HIGHWAY WORK PROPOSAL

<u>COUNTY</u>	<u>STATE PROJECT</u>	<u>FEDERAL</u>	<u>PROJECT DESCRIPTION</u>	<u>HIGHWAY</u>
Fond Du Lac	1440-15-71	WISC 2021227	Fond Du Lac - Plymouth; Ush 151- Seven Hills Road	STH 023

Addendum No. 01
ID 1440-15-71
Revised Sheet 56
February 26, 2021

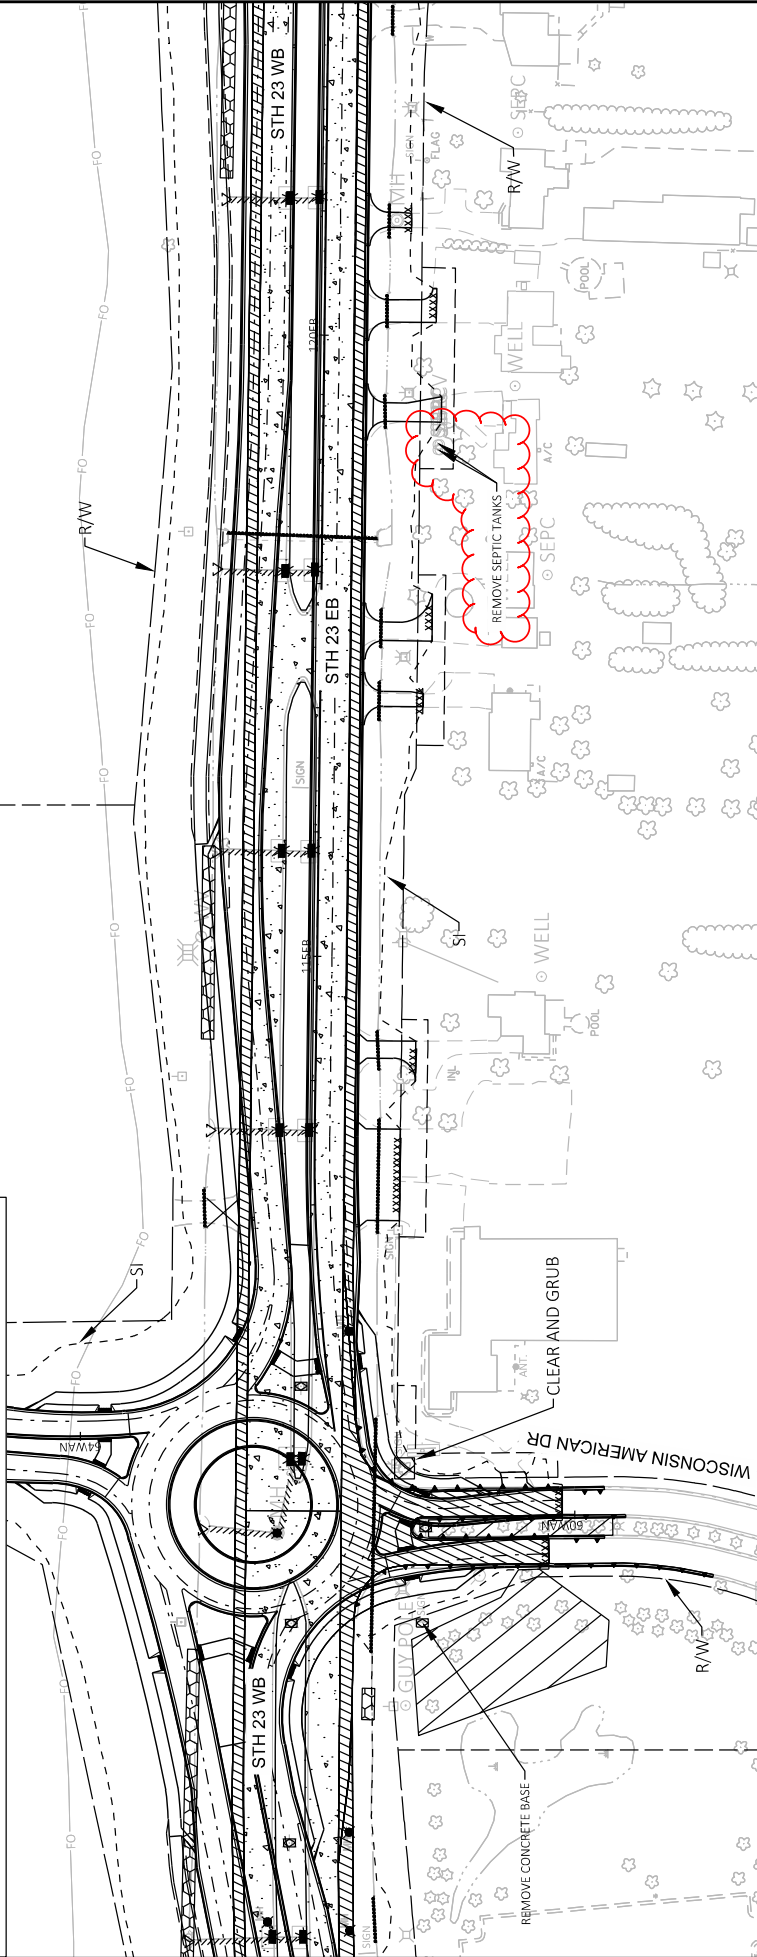
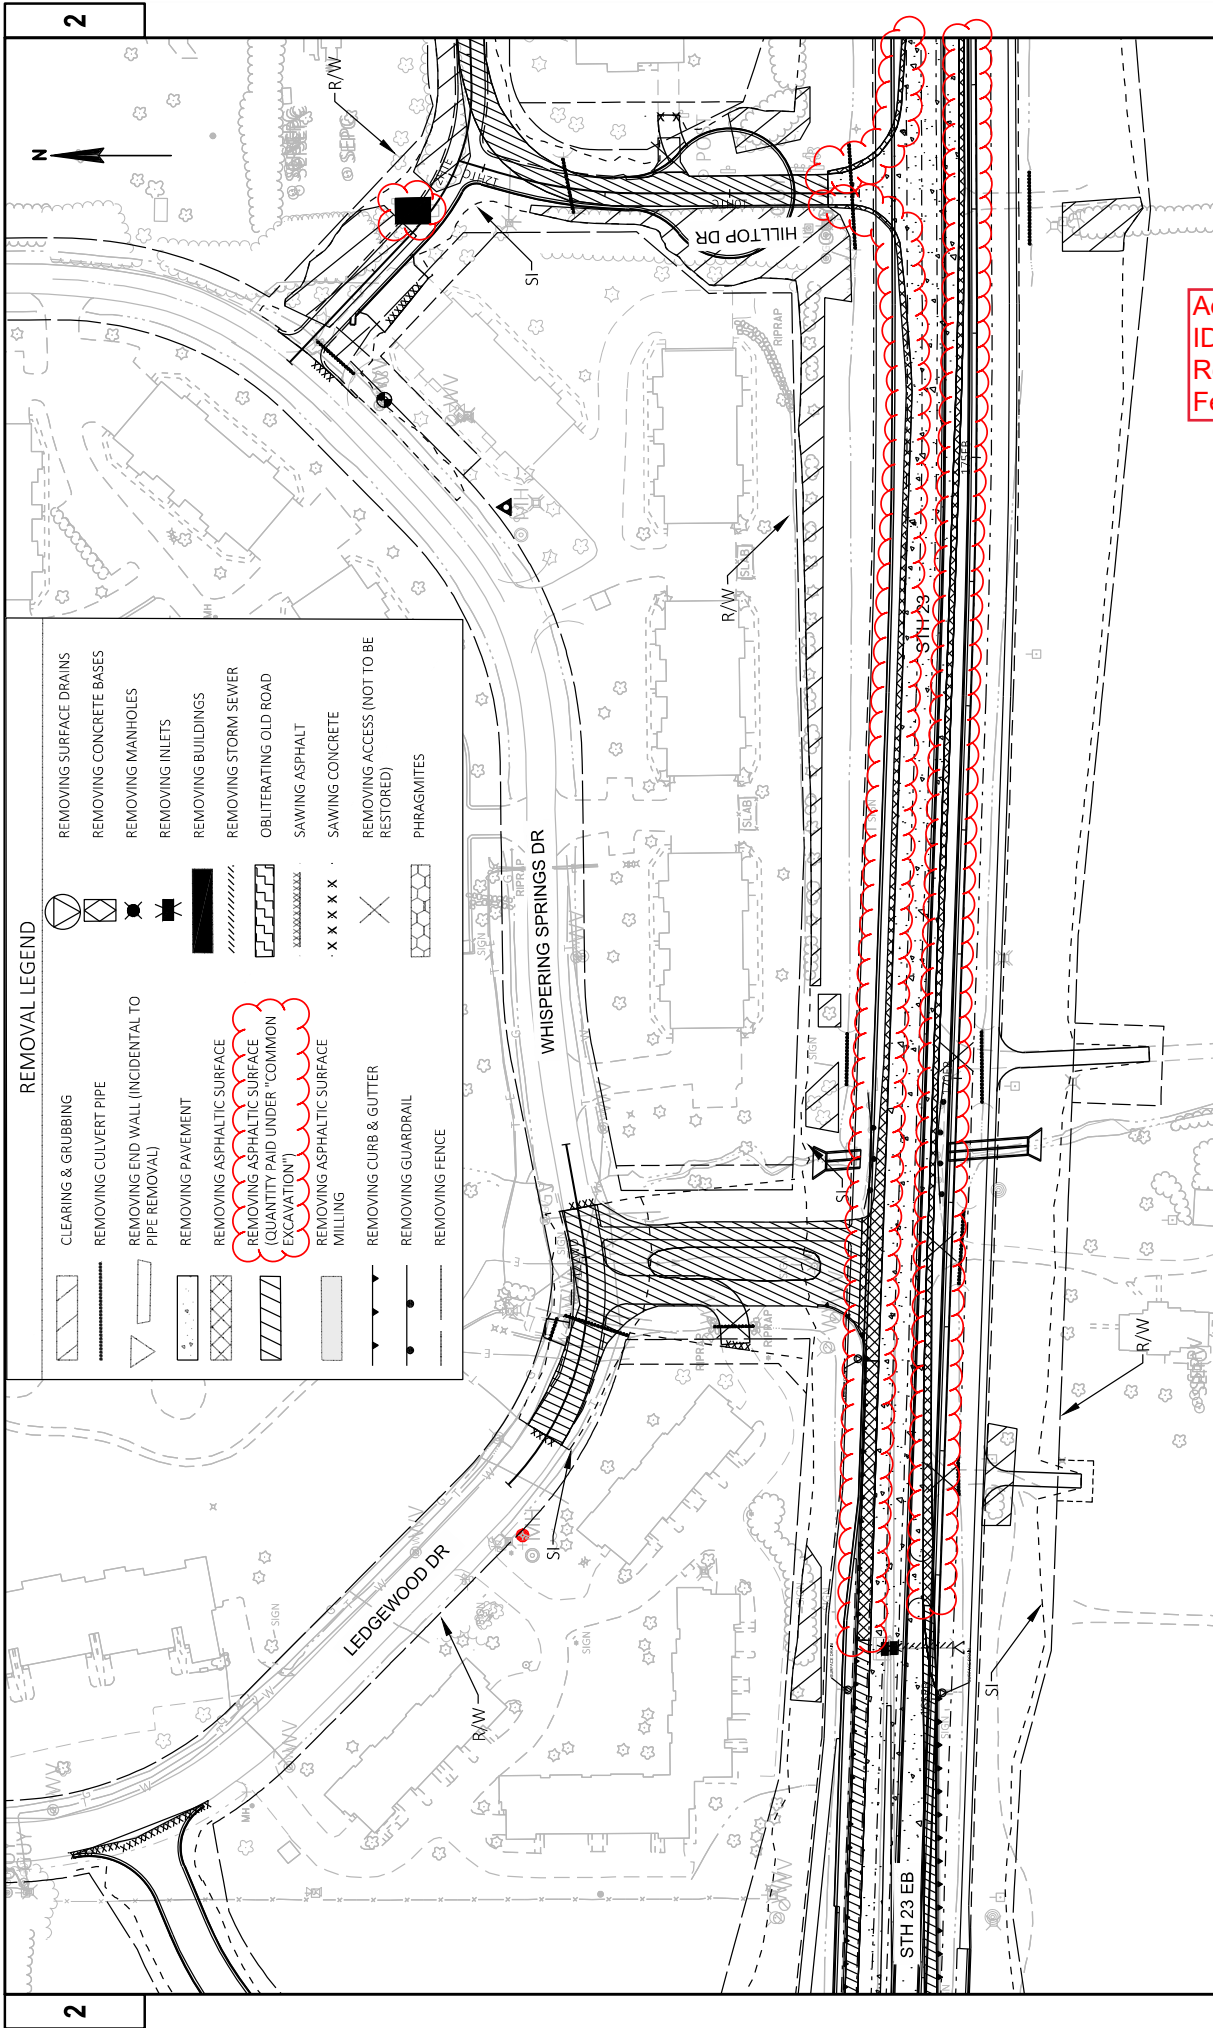
Revised Plan Sheets	
Plan Sheet	Plan Sheet Title (brief description of changes to sheet)
2	General Notes – Utility Contacts Changed
54	Construction Detail: Station 245+11 WB Entrance – Portion of driveway changed to concrete from gravel.
56-66	Removal Plan – Various Changes Due to contractor questions and Real Estate coordination
75-85	Removal Plan – Various Changes Due to contractor questions and Real Estate coordination
146	Plan Details: STH 23 – Driveway from sheet 54 is shown and the driveway type indicator changed.
147	Plan Details: STH 23 – Driveway from sheet 54 is shown and the driveway type indicator changed.
870	Miscellaneous Quantities – Removing Asphaltic Surface Increased for areas of Fill
874	Miscellaneous Quantities – Property Removals revised to eliminate one building and a line that had no quantity on it
882	Miscellaneous Quantities – Concrete Driveway Quantity Table Updated
992	Miscellaneous Quantities – Drilled Shafts added to Type 1 Signs Table
